CHANGE REQUEST

04.08 CR xxx

Source: Ericsson **Date:** 2000-06-19

Subject: Optional support of GEA/2 Encryption Algorithm

Figure 10.5.128/GSM 04.08: MS network capability information element

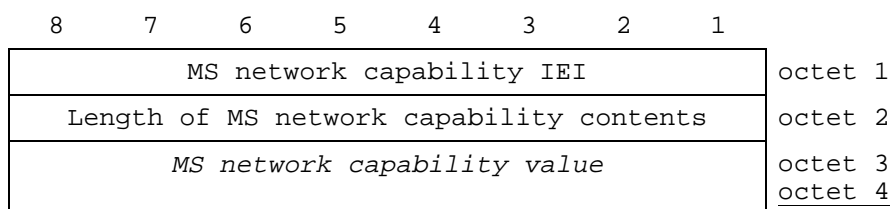
Octet 4 shall be included by the MS, if it supports at least one of the GPRS Encryption Algorithm GEA/2 to GEA/7. Support of octet 4 is optional in the network.

The value part of a *MS network capability* information element is coded as shown in figure 10.5.128/GSM 04.08 and table 10.5.145/GSM 04.08.
